**PLANNED UNIT DEVELOPMENT
& SUBDIVISION STAFF REPORT****Date: August 3, 2006****DEVELOPMENT NAME**

Palisades Apartments Subdivision

APPLICATION NUMBER 14 & 15 DATE August 3, 2006

REQUEST Subdivision & Planned Unit Development

SITE PLAN

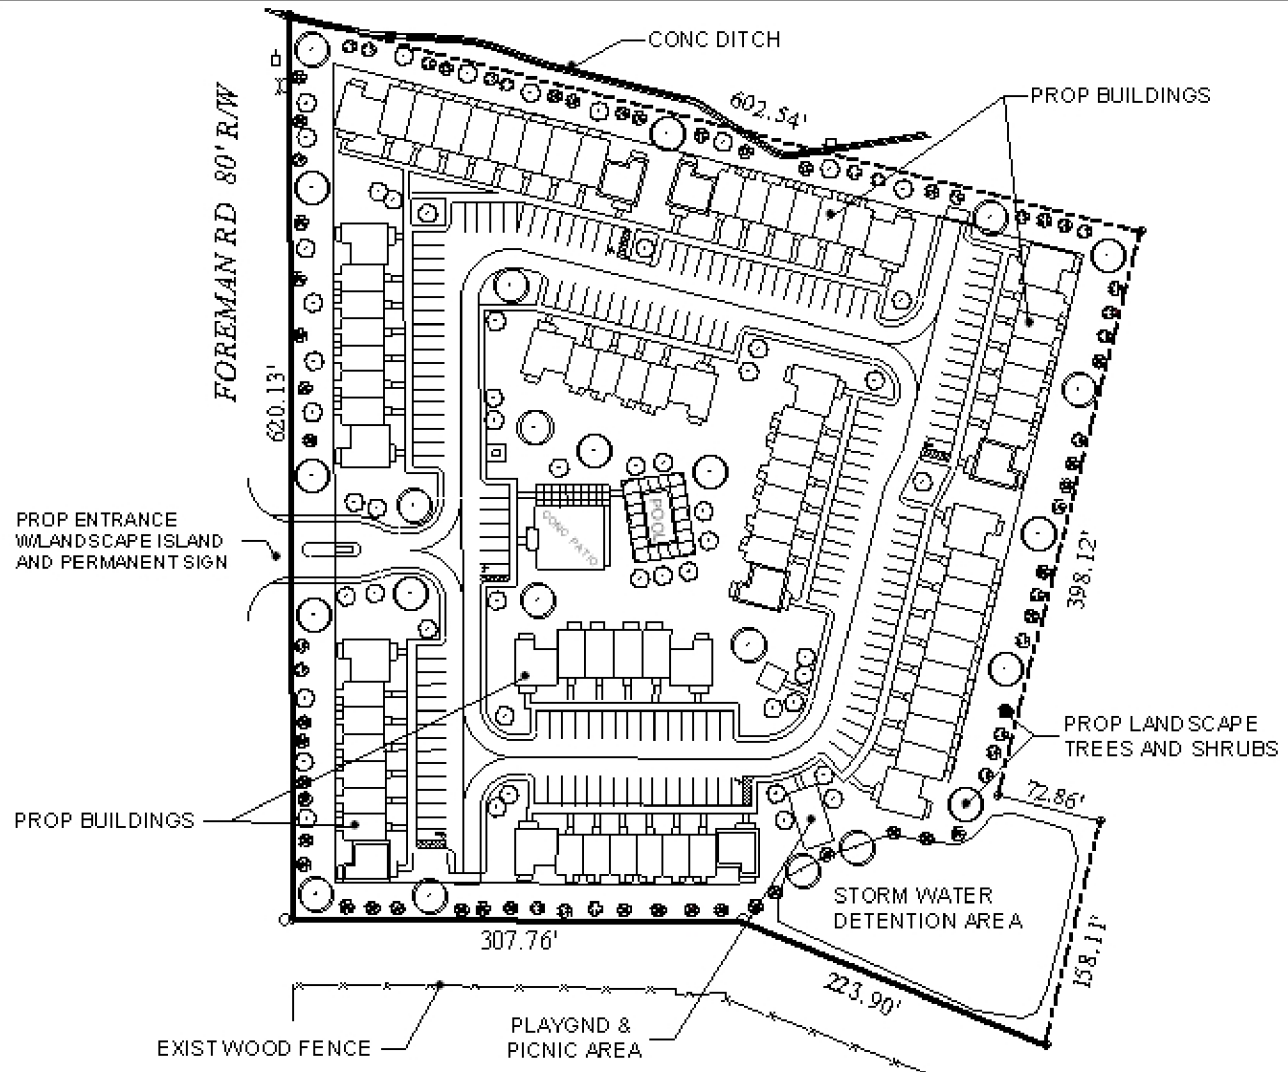
The site plan satisfies the requirements of the Zoning Ordinance regarding building site area, parking, common open space, and setbacks. However, the landscape requirements would not be met. While the 12% overall landscaping requirement is exceeded, the site is so large that landscaping in the front setback cannot meet the 60% of the overall requirement; buildings would have to be moved to accommodate that volume of planting. In addition, the planting plan would not provide heritage and understory trees of the minimum required size and at the minimum required intervals along the street and lot periphery. However, as the site appears to have significant existing tree cover, it may be appropriate to allow a reduced percentage of streetside landscaping, in exchange for maintaining a larger overall proportion of landscaping, and keeping as many of those existing trees as practicable. The required heritage and understory should be maintained or provided as required by the Zoning Ordinance; however, it is recommended that the developer be allowed to keep the buildings in their proposed locations, in exchange for providing a greater share overall of landscaping—perhaps 25%—by new planting or retention of existing vegetation. According to the site plan, all structures, parking, driveways, and detention would only consume approximately half of the site; so this figure (25%) may already be provided.

The concrete ditches illustrated to the North and South of the property are matters of concern, especially regarding the safety of children residing at the site. In addition, it has traditionally

been the practice of the Planning Commission to require a buffer between multi-family and single-family districts. While the landscaping plan calls for “screen shrubs” along the property lines, these plantings as shown would not meet the Ordinance standards for vegetative buffering. Due to these concerns, it is recommended that a privacy fence be required along the North and South property lines, in accordance with Section IV.D.1 of the Ordinance. As the property to the East does not include a ditch, and it is also zoned R-3, no buffer would seem necessary there.

Planned Unit Development: Based on the preceding, this application is recommended for Approval, subject to the following conditions: 1) full compliance with the heritage and understory tree requirements of the Zoning Ordinance, as it relates to the front and periphery of the lot; 2) that the site retain a minimum of 25% landscaping, with retention of existing vegetation where practicable; 3) the provision of a privacy fence in compliance with Section IV.D.1, along the North and South property lines; 4) that all dwelling units are fitted with an automatic sprinkler system installed in accordance with Section 903.3.11 or 903.3.1.2 of the International Fire Code, per Fire Department comments; and 4) full compliance with all municipal codes and ordinances.
